Model: Bellini-C2		Date: 25-Mar-03	No.: MB070001
Modified Article: Transport Screw: T=20		Prepared by: F.Noguchi	
From: Technical Services Sec. Service Planning Dept.			
Reason for Modification:	☒ Parts catalog correction ☐ To facilitate assembly ☐ Part standardization	☐ Vendor change ☐ To improve reliability ☐ Other	☐ To meet standards ()

Model: Bellini-C2		Date: 11-Apr-03	No.: MB070002
Modified Article: ARDF		Prepared by: F.Noguchi	
From: 2nd Tech. Support Sec. Service Support Dept.			
Reason for Modification:	☒ Parts catalog correction ☐ To facilitate assembly ☐ Part standardization	☐ Vendor change ☐ To improve reliability ☐ Other	☐ To meet standards ()

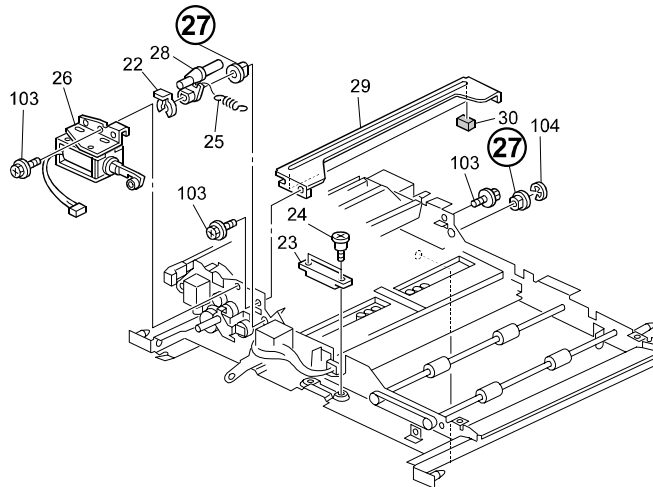
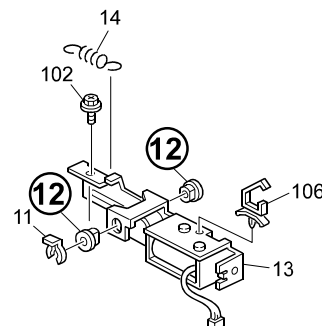
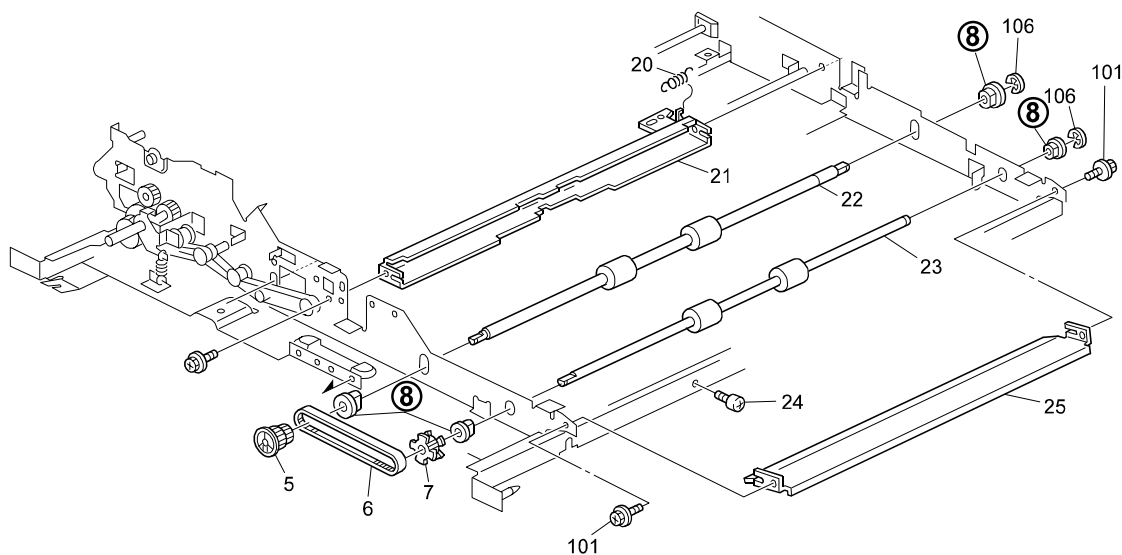
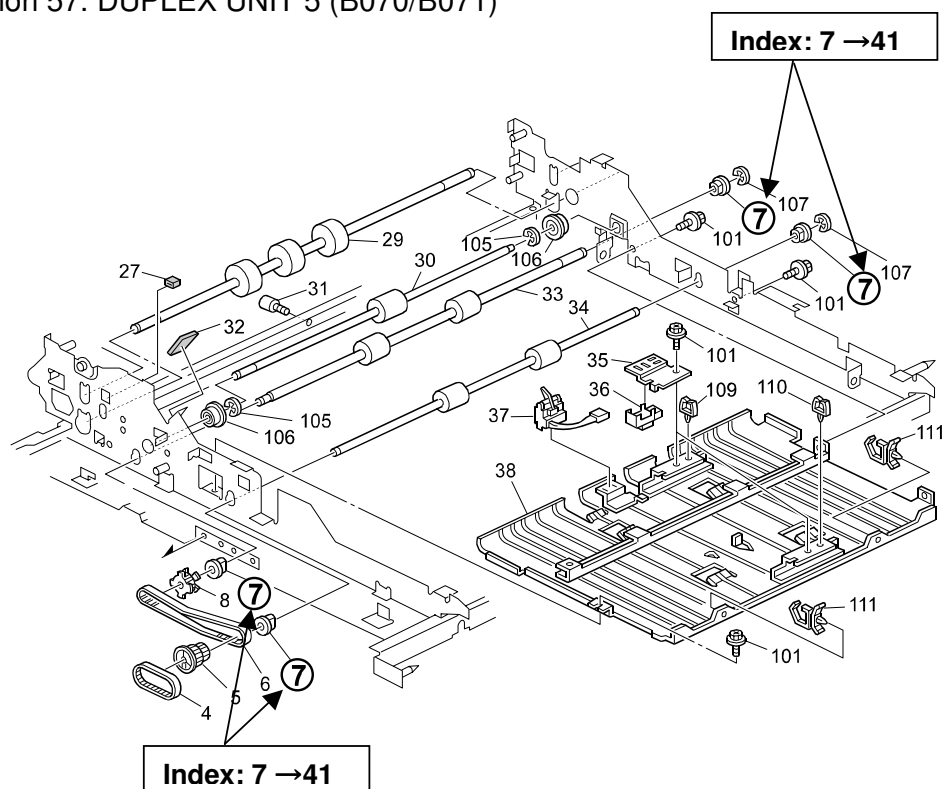
Old part number	New part number	Description	Q'ty	Int	Page	Index	Note
50530447		Bushing – 6mm	2 - 0	X/	121	27	
			2 - 0		123	12	
			4 - 0		127	8	
			5 - 1		129	7	
	AA082118	Bushing – M6	0 - 2	/O	121	27	
			0 - 2		123	12	
			0 - 4		127	8	
			0 - 4		129	*41

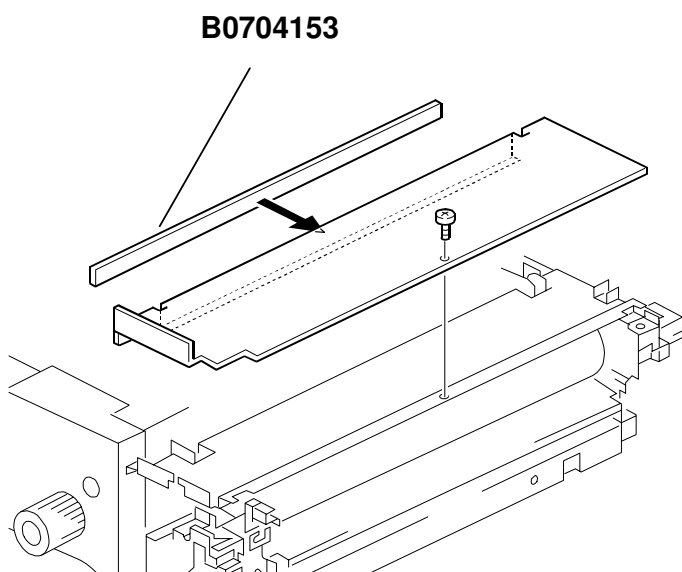
A new insulation sheet has been added between the fusing upper cover and the fusing exit guide plate. This helps to decrease the temperature of the fusing exit guide plate.

Note: The new insulation sheet is attached on the side of the fusing upper cover.

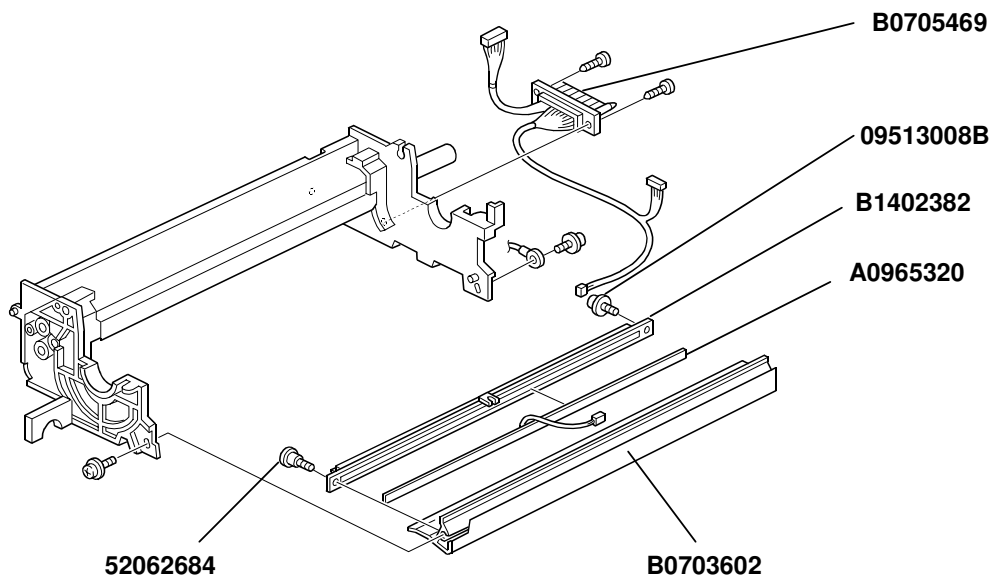
A PTL (Pre-Transfer Lamp) has been added to further ensure proper drum separation. In accordance with this change, the BCU and drum harnesses have also been changed.

Old part number	New part number	Description	Q'ty	Int	Page	Index	Note
B0703510	B0703511	PCU:Lower:Ass'y	1	X/O	97	*	
B0705466	B0705469	Harness:PCU	1	X/O	99	11	*1
A2943559	B0703602	Upper Stay – Transfer Unit	1	X/O	99	13	*1
-	A0965320	Quenching Lamp	1	-	99	*32	*1
-	B1402382	Pre-transfer Lamp Case Ass'y	1	-	99	*33	*1
-	09513008B	Philips Screw With Flat Washer – M3x8	N+1	-	99	101	*1
-	52062684	Shoulder Screw – M3	1	-	99	*34	*1
B0705453	B0705468	Harness:Drum:Machine Or Copier	1	X/O	135 143	10 17	*1
B0706701	B0706716	PCB:BCU:NA:Ass'y	1	X/O	143 175	16 *	*1
B0706751	B0706766	PCB:BCU:EU:Ass'y	1	X/O	143 175	16 *	*1

B0706849

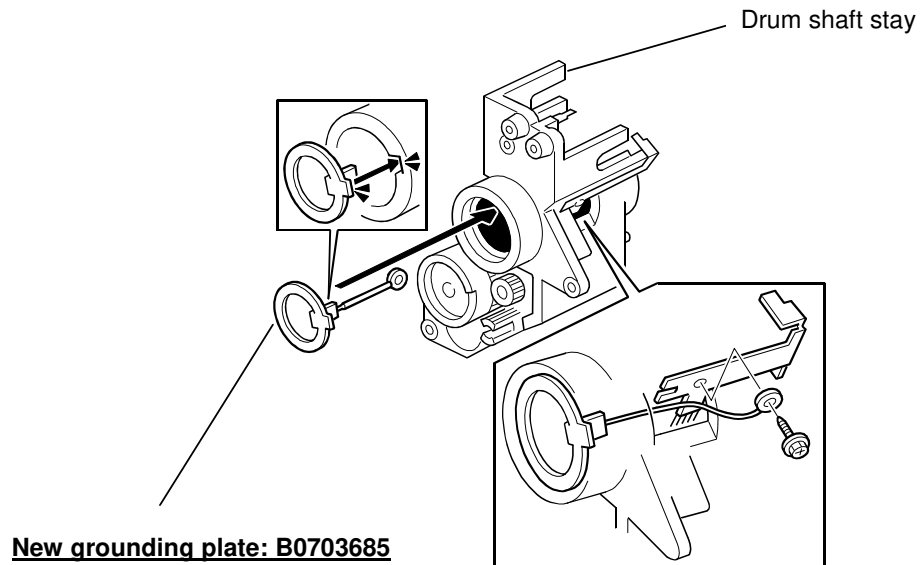
In order to further ensure working safety, a protective cover has been added to the entire area surrounding the positioning bracket on the controller box.

B0704825 Entrance Guide

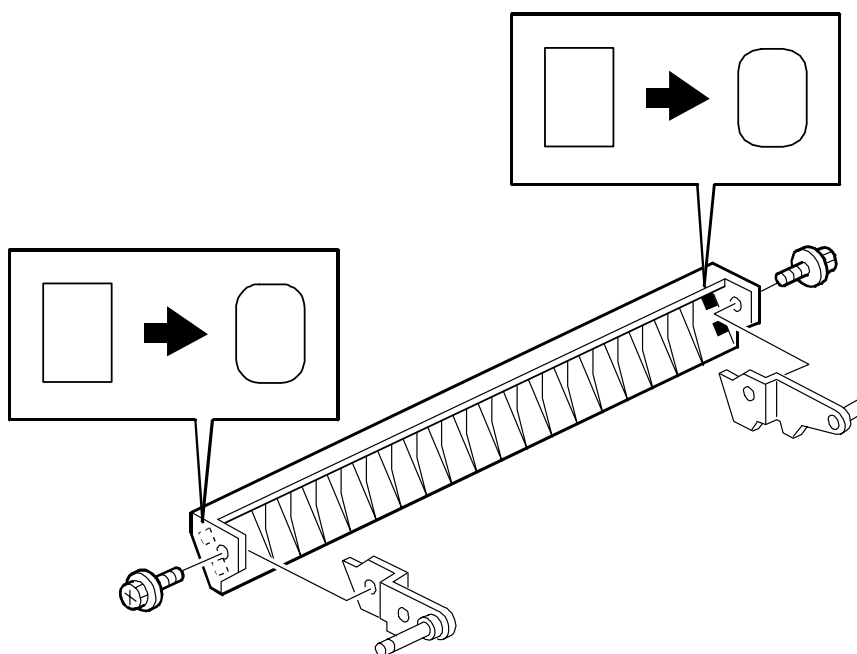
Old part number	New part number	Description	Q'ty	Int	Page	Index	Note
B0704831	B0704825	Entrance Guide	1	X/O	123	16

Change: The shape of the holes was changed.

Reason: To increase the strength and reliability of the entrance guide.
